Re: 3300-10-037, Chinese Bible Church of San Diego
Addendum to Visual Study

**Visual Resources Impact
Report
The Chinese Bible Church
of San Diego**

PDS2014-SPA-14-001; PDS2010-3300-10-
037(MUP); PDS2010-3940-12-002(VAC);
PDS2014-3910-9508007L(ER)

**Figure
1**

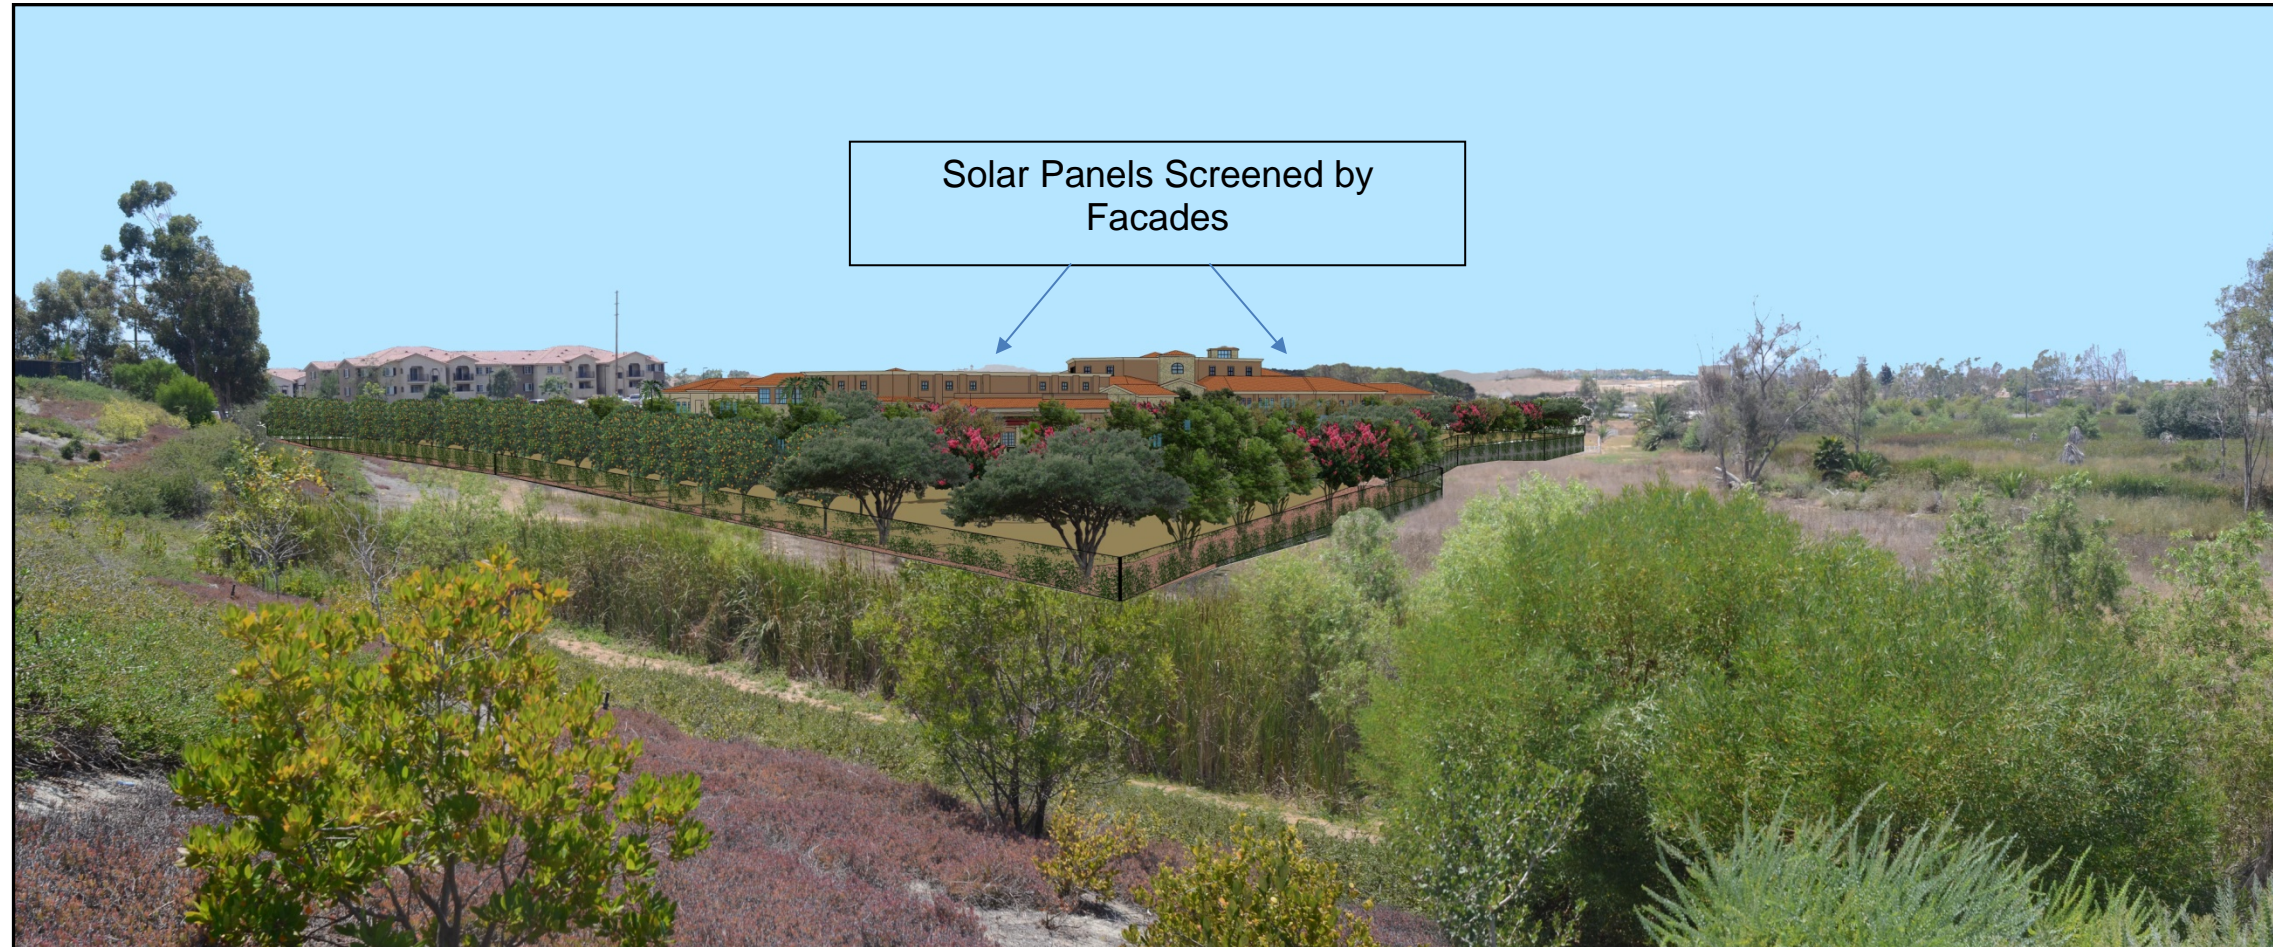
1. Solar panels will be installed on the roofs of the buildings
2. Building facades will screen the panels from view
3. The surface of the solar panels will incorporate a non-glare finish

Current building designs allow for the positioning of panels on the roof, behind the building façade.

Three photo-simulations are provided that illustrate the resulting visual effect. These depict mid-distance, distant, and close-distance views. The mid-distance and distant views are at elevations above the site, while the close-distance view is approximately at the same level as the project. The simulations show that neither the structure of the panels nor glare would be visible. As shown, visual impact are avoided with the incorporation of these design measures.
